A/FLN/22

**Section 16 Planning Application for
Temporary Shop and Services, Place of Entertainment,
Place of Recreation, Sports or Culture (Barbecue Site) and
Public Vehicle Park (excluding container vehicle) for a Period of 3 Years
at Lots Nos. 517 RP, 518 RP, 521 RP, 522, 523 RP, 524 RP, 525, 526,
527 RP, 532 RP (Portion), 533 RP (Portion), 534 RP (Portion),
539 (Portion), 540 (Portion), 541 (Portion), 542 (Portion), 543 (Portion),
544, 545, 547 (Portion), 548 (Portion), 551 (Portion), 552 and 553,
and Adjoining Government Land in D.D. 51
Fu Tei Au and Shek Wu San Tsuen, Sheung Shui, North, New Territories**

Section 16 Planning Application No. A/FLN/22
Temporary Shop and Services, Place of Entertainment,
Place of Recreation, Sports or Culture (Barbecue Site) and
Public Vehicle Park (excluding container vehicle) for a Period of 3 Years
at Lots Nos. 517 RP, 518 RP, 521 RP, 522, 523 RP, 524 RP, 525, 526,
527 RP, 532 RP (Portion), 533 RP (Portion), 534 RP (Portion),
539 (Portion), 540 (Portion), 541 (Portion), 542 (Portion), 543 (Portion),
544, 545, 547 (Portion), 548 (Portion), 551 (Portion), 552 and 553,
and Adjoining Government Land in D.D. 51
Fu Tei Au and Shek Wu San Tsuen, Sh

Site Layout Plan for Application Site A & Site B

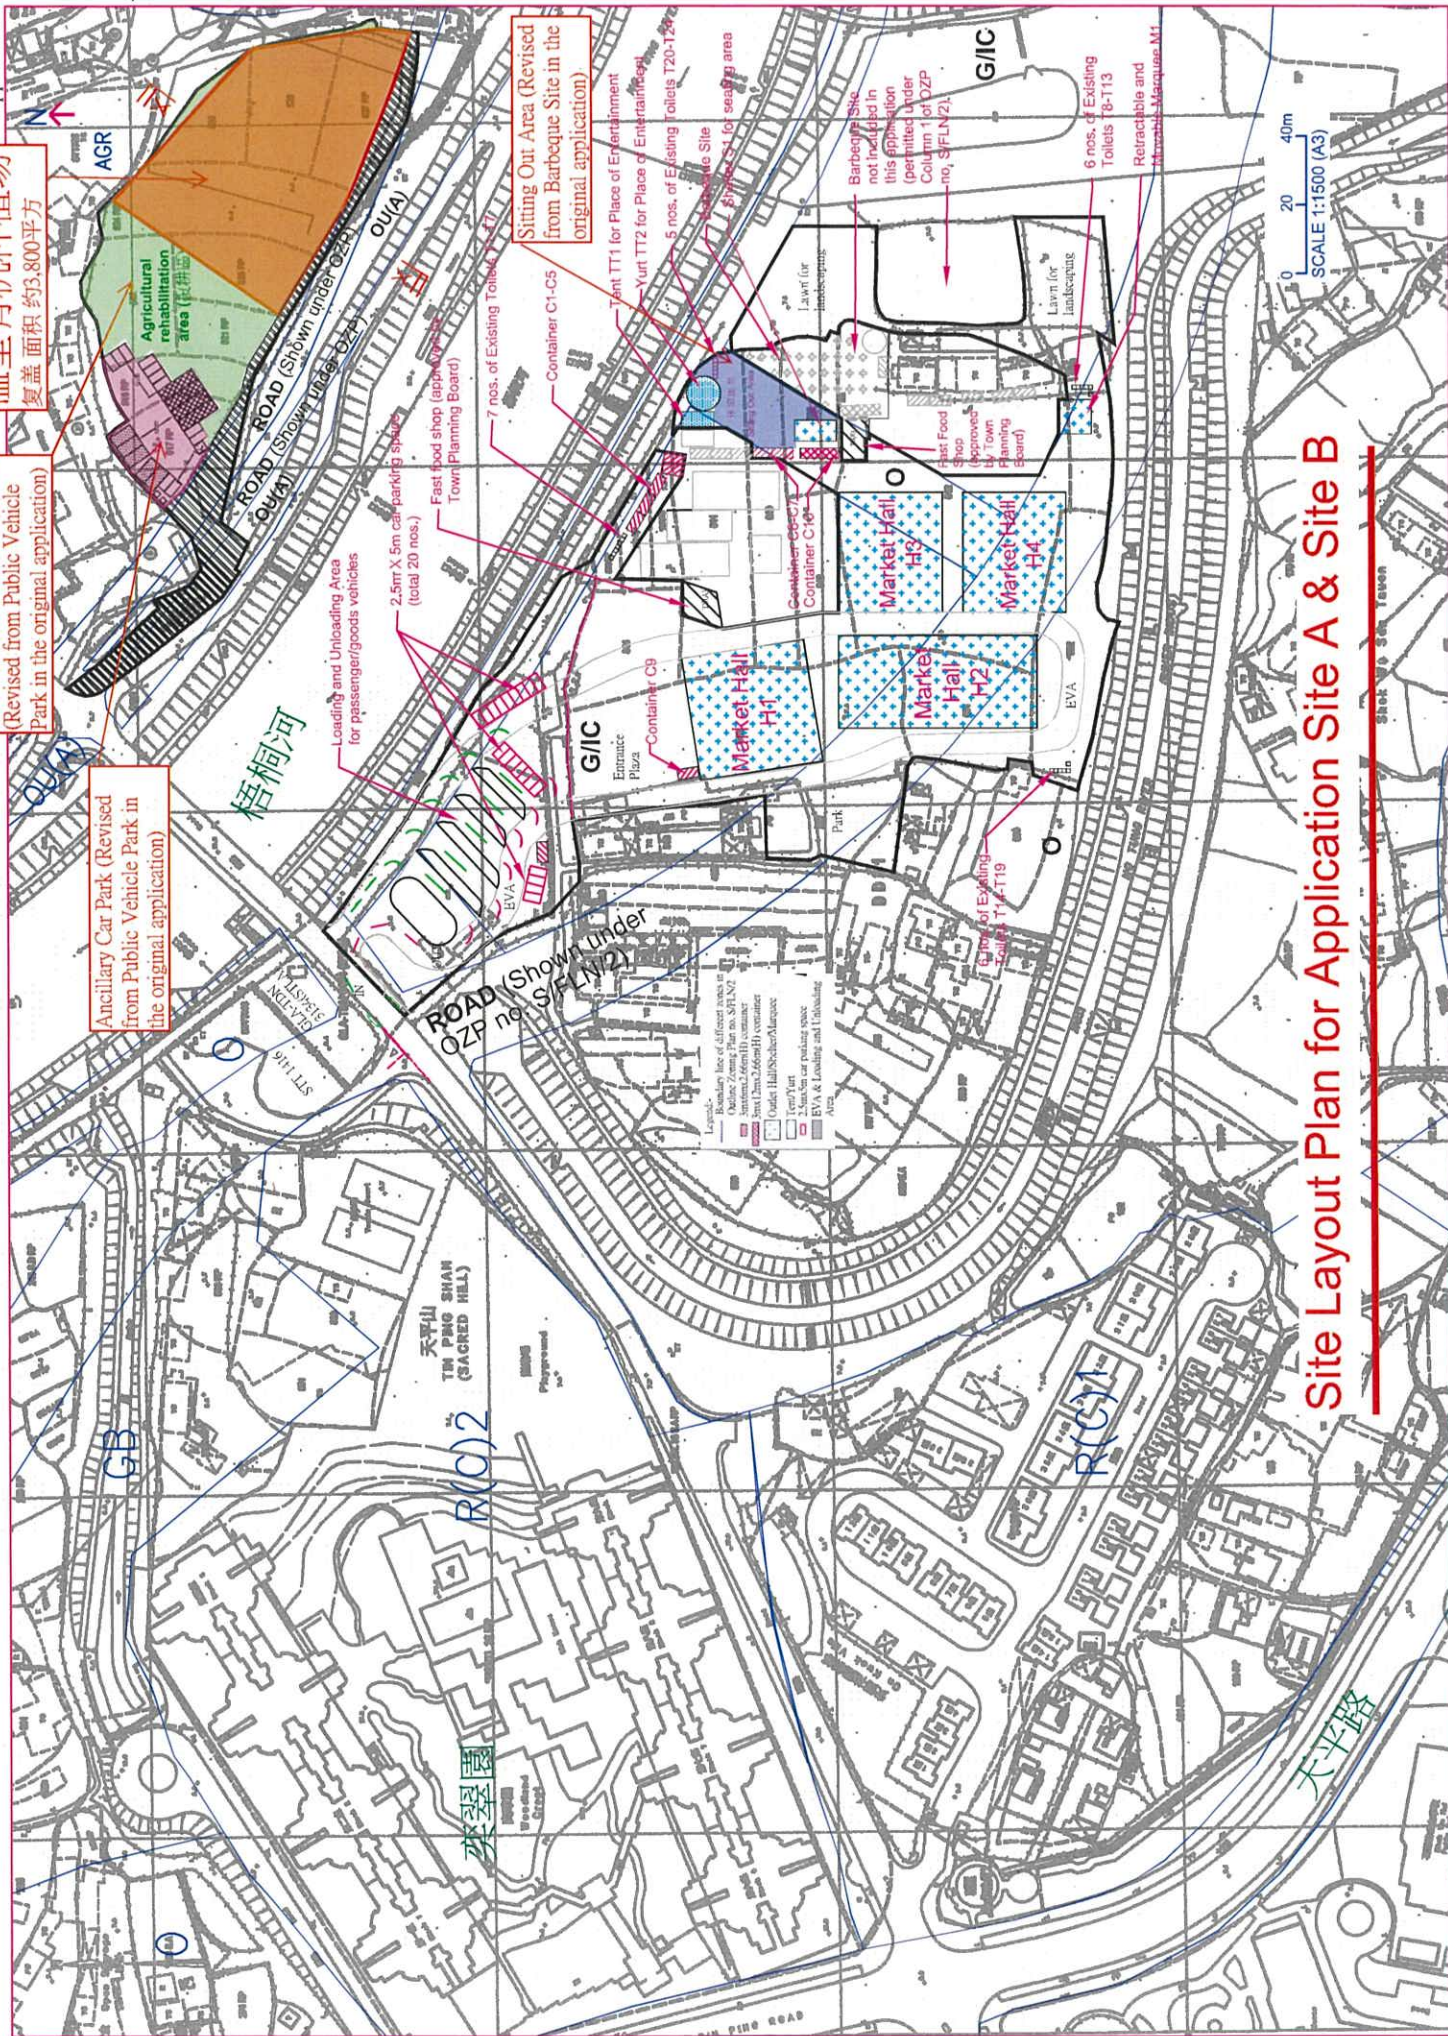
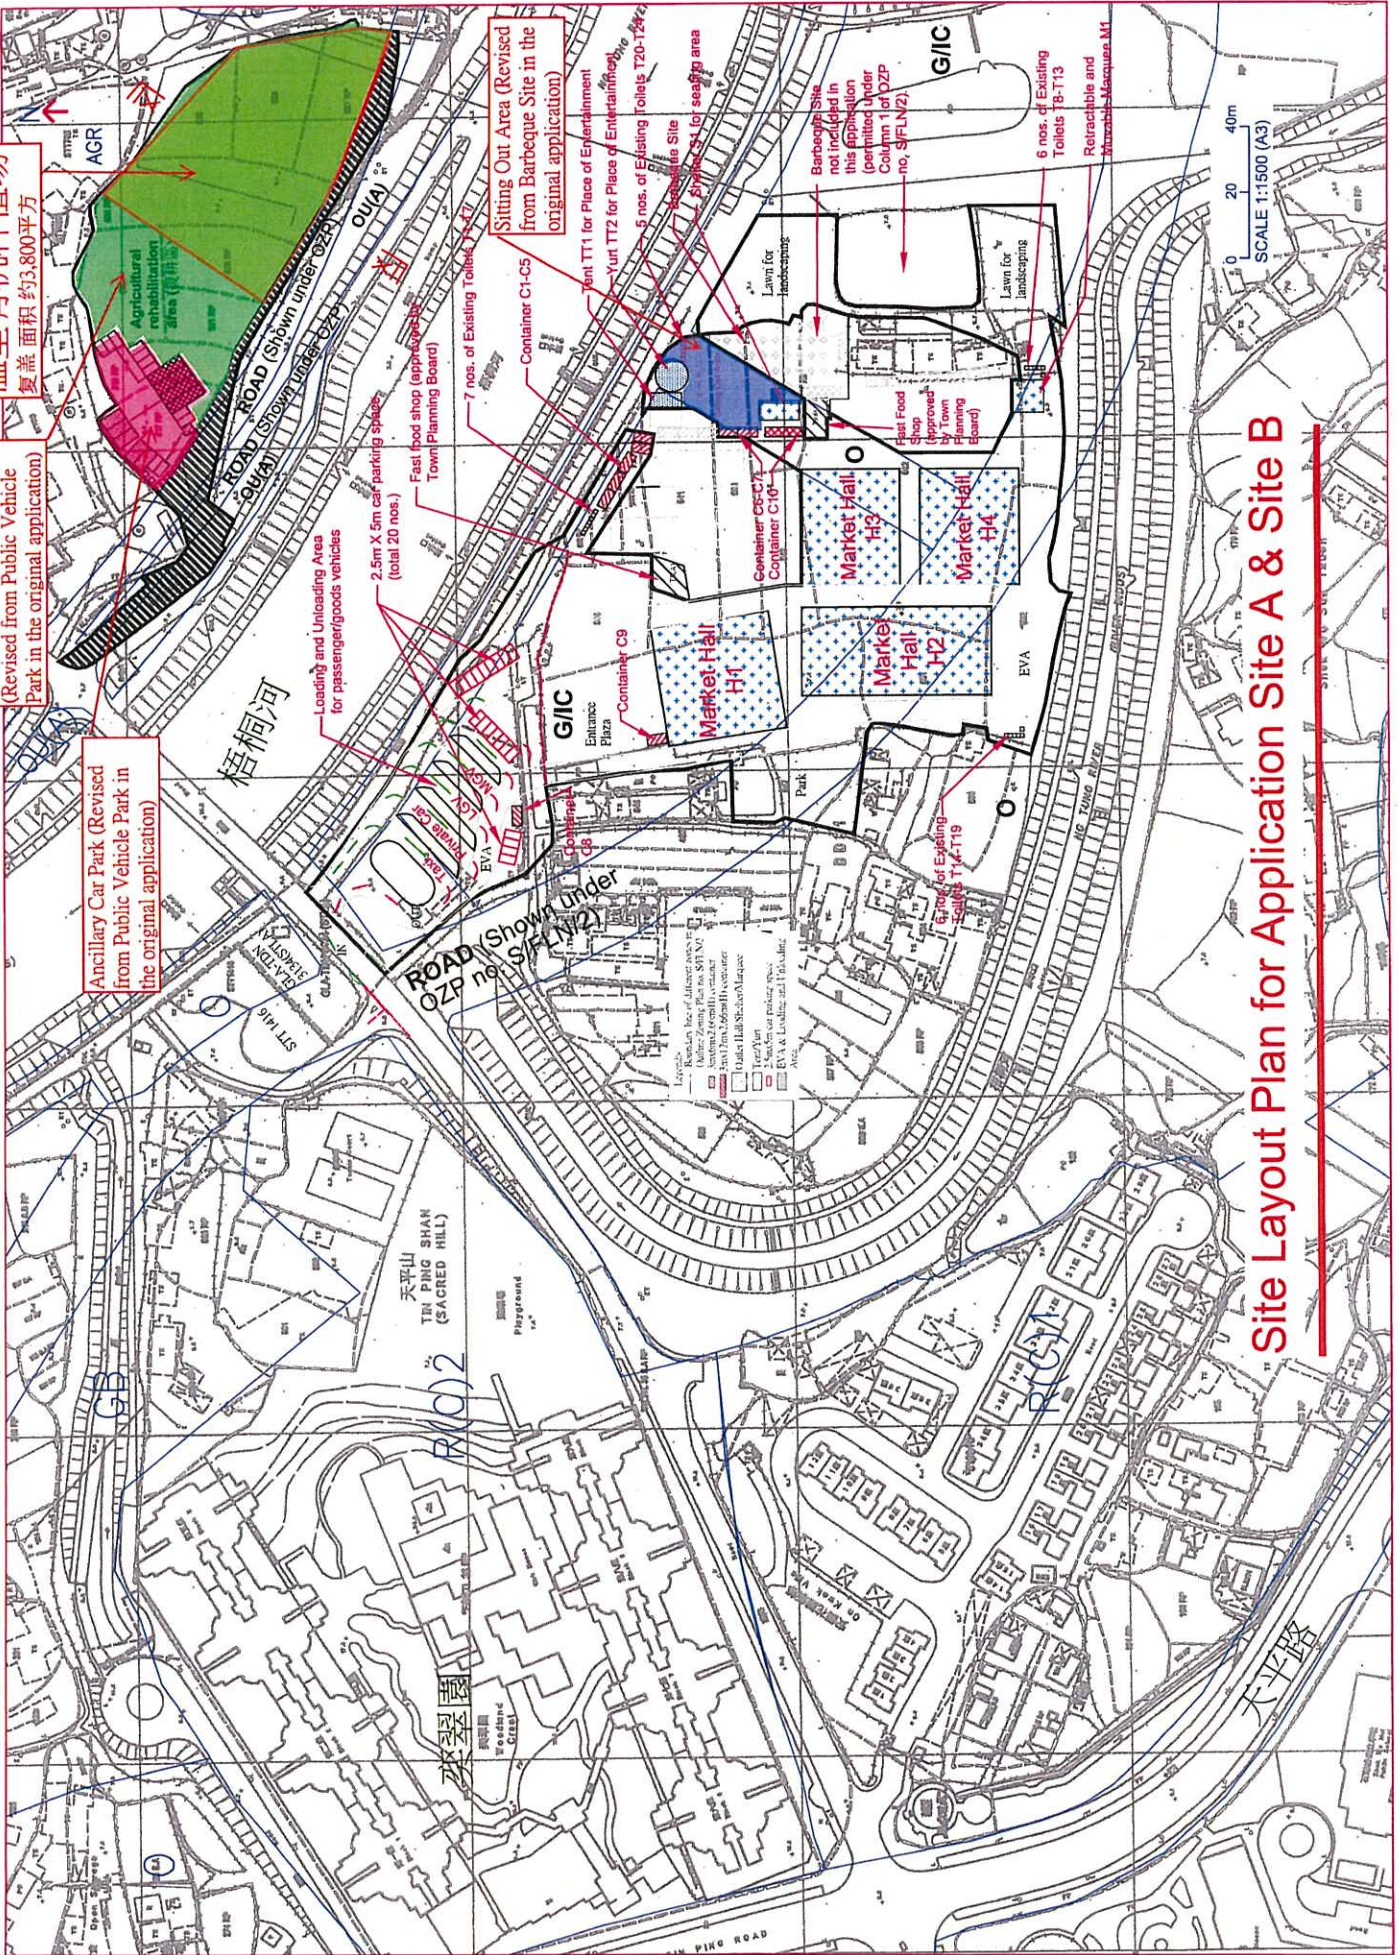
DAFC did not support the applied use of public vehicle park (excluding container vehicle) "Public V/P") at Site B which is zoned "Agriculture" on the approved Fu Tei Au and Sha Ling Outline Zoning Plan No. S/NE-FTA/16 in the first submission. A meeting was held on 3 September 2020 with Ms Hui of AFCD, Miss Winnie Lau who was the then District Planning Officer/FS & YLE and Mr Patrick Fung of DPO/FS & YLE, the Applicant and the undersigned. Miss Lau asked the Applicant to consider DAFC's comment on the original applied use, i.e. Public V/P. Eventually, the Applicant accepted Miss Lau's advice. The major portion of Site B is now amended for agricultural rehabilitation. Please see the summary of the current applied uses at Appendix C and the site layout plan at Appendix D.

although the Applicant agreed not to proceed with Public V/P and to change the major portion of Site B from Public V/P to agricultural rehabilitation, DAFC still did not support the amended scheme at Site B during the preliminary enquiry. DPO/FS & YLE relayed DAFC's comments on the revised proposal of agricultural rehabilitation on 5 March 2021 as follows:-

Agricultural Rehabilitation Area
(Revised from Public Vehicle
Park in the original application)

Ancillary Car Park (Revised
from Public Vehicle Park in
the original application)

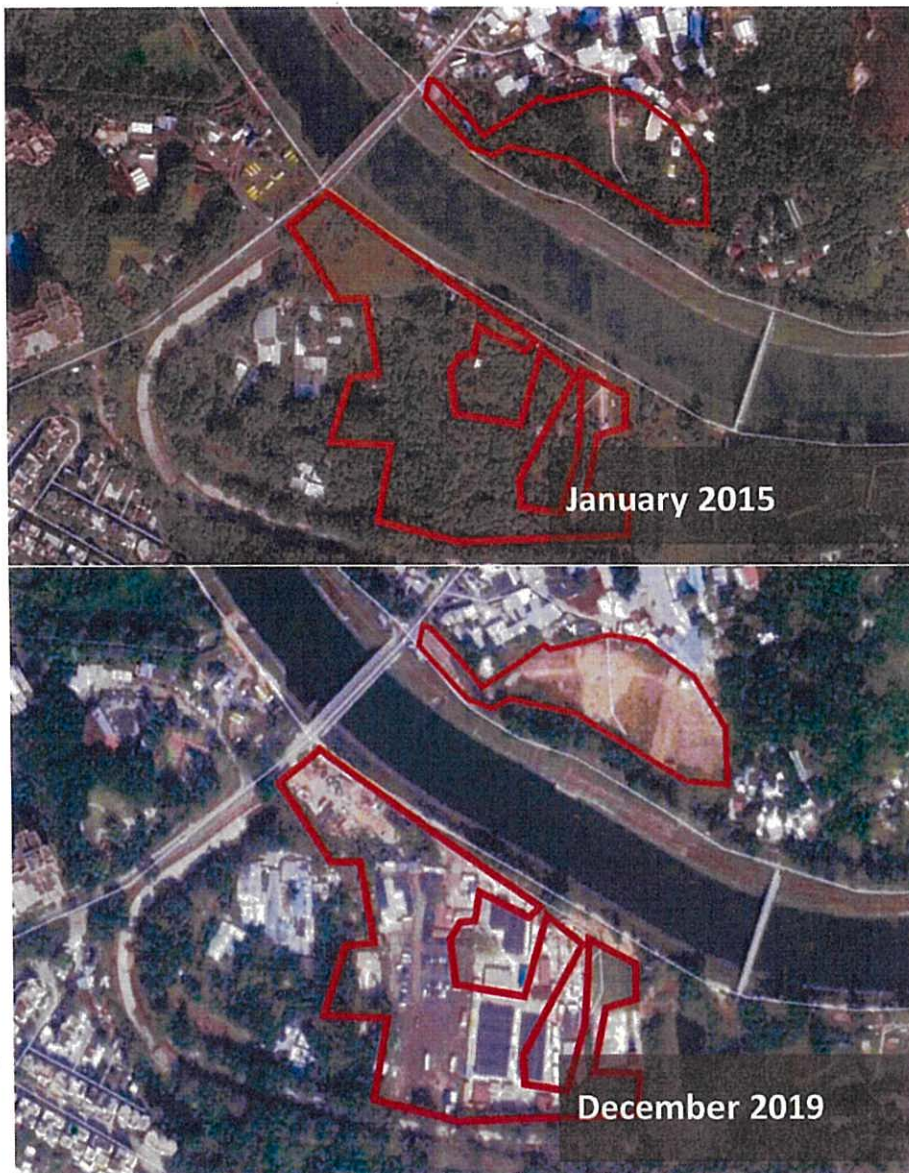
- 2 **The Town Planning Board should not encourage "destroy first, build later"**
From Google Earth aerial photographs, landscape changes including vegetation clearance, site formation and storage of temporary structures were seen at the application site between 2015 and 2019 (Figure 1). We suspect that this is "destroy first, build later". We are concerned the approval of the current application would further legitimize the current misuse of the AGR zone, leading to the promotion
